FERMI-2

AMENDMENT TO FACILITY OPERATING LICENSE

Amendment No. 77
License No. NPF-43

ATTACHMENT TO LICENSE AMENDMENT NO. 77

FIGURE 3.4.6.1-1

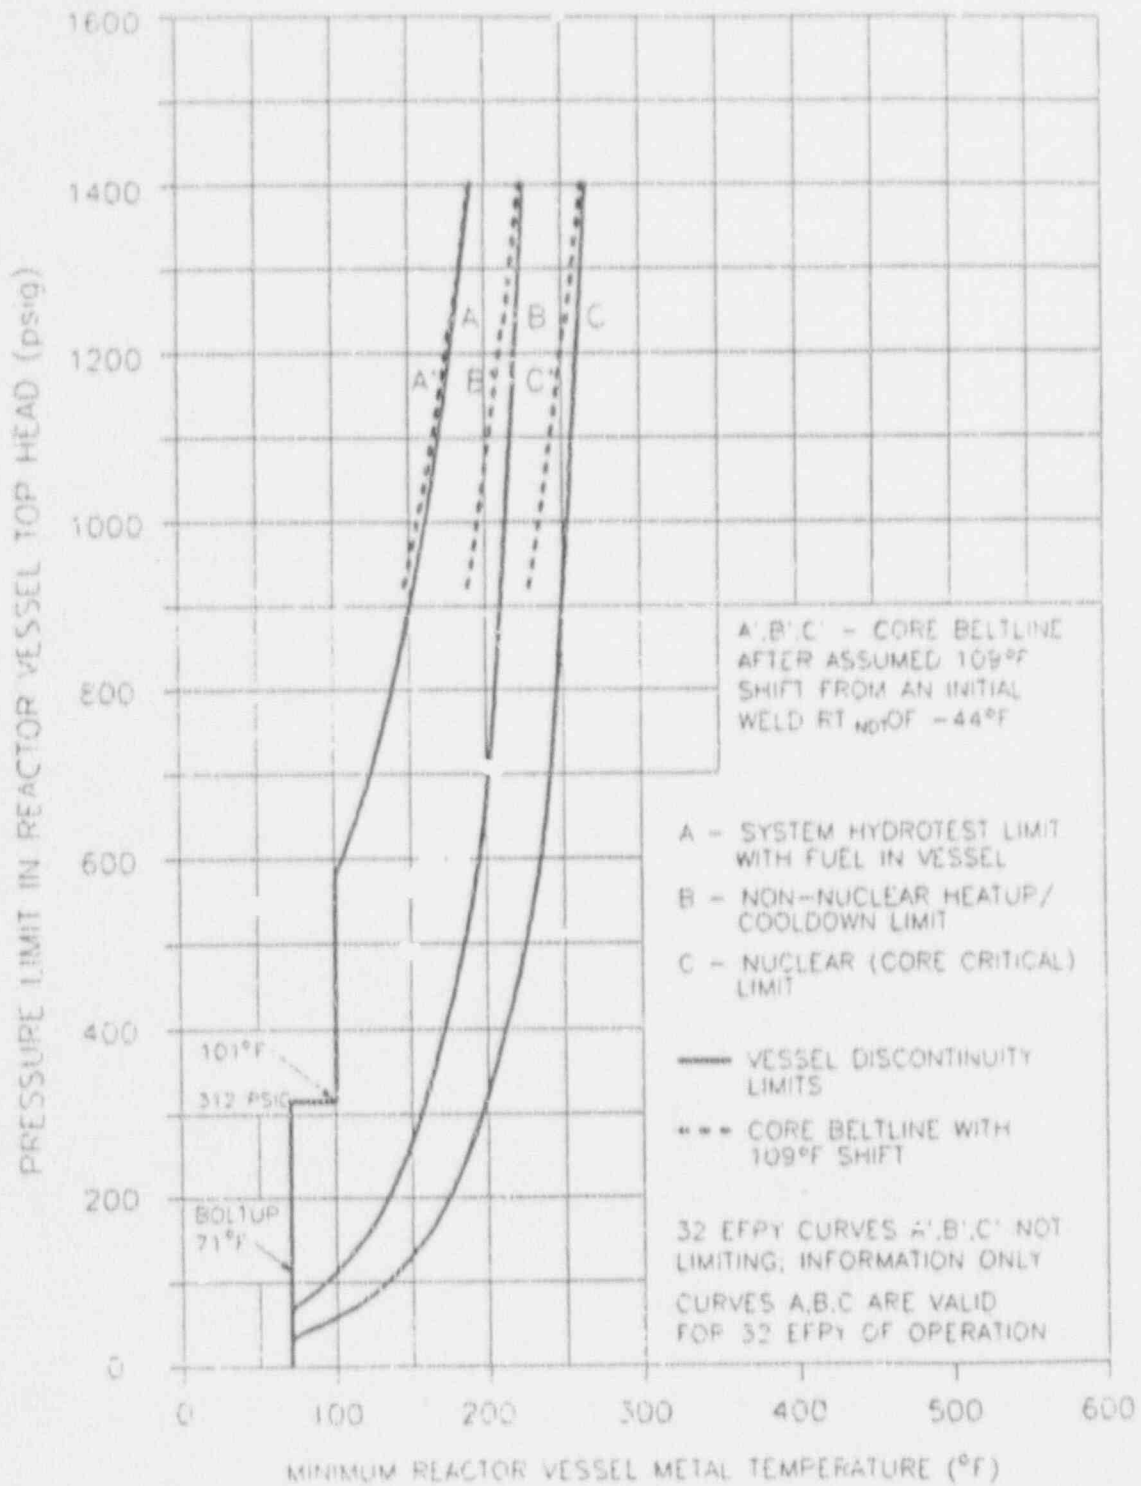
3.4.6.1 The reactor coolant system temperature and pressure shall be limited in accordance with the limit lines shown on Figure 3.4.6.1-1 (1) Curve A for hydrostatic or leak testing; (2) Curve B for heatup by non-nuclear means, cooldown following a nuclear shutdown and low power PHYSICS TESTS; and (3) Curve C for operations with a critical core other than low power PHYSICS TESTS, with:

4.4.6.1.1 During system heatup, cooldown and inservice leak and hydrostatic testing operations, the reactor coolant system temperature and pressure shall be determined to be within the above required heatup and cooldown limits and to the right of the limit lines of Figure 3.4.6.1-1 Curves A, B, or C, as applicable, at least once per 30 minutes.

4.4.6.1.2 The reactor coolant system temperature and pressure shall be determined to be to the right of the criticality limit line of Figure 3.4.6.1-1 Curve C within 15 minutes prior to the withdrawal of control rods to bring the reactor to criticality and at least once per 30 minutes during system heatup.

4.4.6.1.3 The reactor vessel material surveillance specimens shall be removed and examined, to determine changes in reactor pressure vessel material properties, as required by 10 CFR Part 50, Appendix H in accordance with the schedule in Table 4.4.6.1.3-1. The results of these examinations shall be used to update the curves of Figure 3.4.6.1-1.
